Product Advisory

Adapter modification for improve ESD protection

BCM957416A4160C Generic / Channel

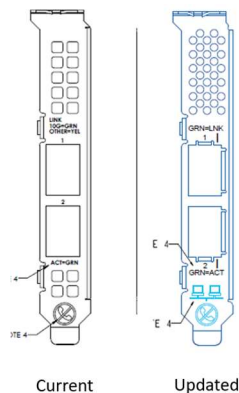
As part of on-going quality improvements, the WH+ 10GBASE-T P210tp channel adapter is being updated to improve ESD protection in order to provide better performance. An EMI absorber around the WH+ ASIC is being added under the heatsink. The absorber has no impact on functionality and helps reduce EMI. Also, the bracket is being updated to improve the ground path around the connector to reduce ESD and to conform to Broadcom's latest standardized bracket solution. These changes include different vent hole openings and minor changes to the labeling as shown in the picture below. Other than improving ESD shielding, the bracket changes have no other functional impacts.
